CWSP SYSTEM HARDENING FIELD SCOPING DOCUMENT

PM: [REDACTED]	Project Name: SH - BUCKS CREEK 1101 CB	
Notification: [REDACTED]	Region: Northern	City: Rock Creek
Project Manager: [REDACTED]	Division: North Valley	County: Plumas

- A) **Project Area** – Google Earth Image with Circuit and HFTD Tier 2 &3 Overlay

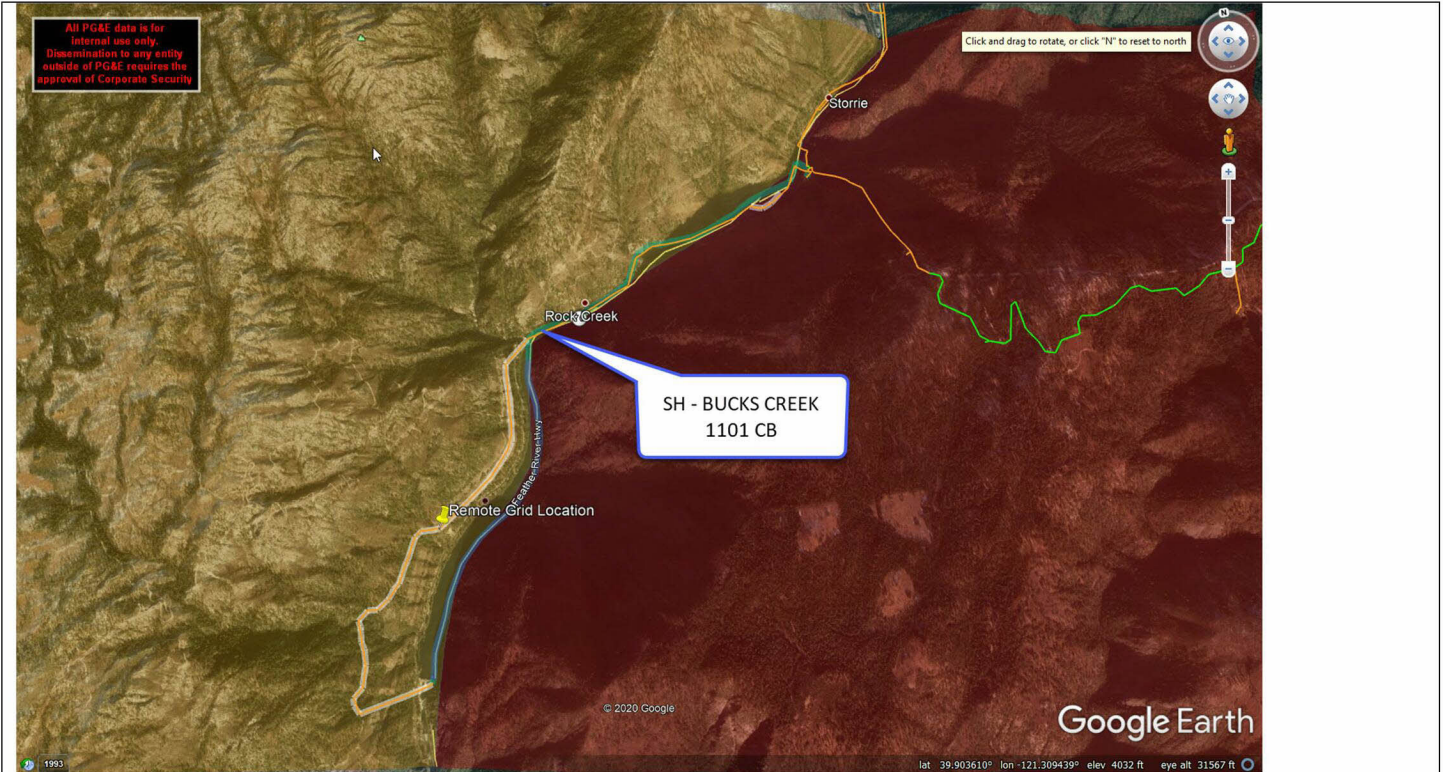
- The Bucks Creek 1101 project is in Plumas County. The project originates near the community of Storrie and continues westerly along Highway 70 and the North Fork of the Feather River down to the Cresta Powerhouse.
- Fuel types are consistent with moderate to heavy brush and mixed conifer, however the general area has been heavily fire scared and the fire scar areas are intermixed with a significant amount of standing and down dead fuel.
- The community of Storrie is at the eastern end of the project has only a few residents. The Feather River Canyon area is sparsely populated. Larger communities exist much farther to the east in Quincy, Plumas County and west in Concow, Butte County.

- This area has significant fire history directly impacting the project area. A 20 year look back at area fire history includes, the 56,000 acre Storrie fire (2000), 8,000 acre Poe fire (2001), 1700 acre Highway 70 fire (2001), 50,000 acre Butte Lightning Complex (2008), Canyon Complex (2008), 30,000 acre Chips Fire (2012), 154,000 acre Camp fire (2018) and the 320,000 acre North Complex 2020 all burned within the Feather River Canyon.

- Not all the fires were directly in the project footprint area; however, they show that this area is prone to significant, large fire history due in large part to steep, rugged, inaccessible terrain and periods of strong wind.

- The Feather River drainage is prone to daily diurnal winds and strong north/Diablo wind events at various times of the year, but most notably during the fall period when fuels are at their driest. These conditions have resulted in the area being affected routinely by PSPS events and has also resulted in many large, devastating fires originating in the Feather River drainage.
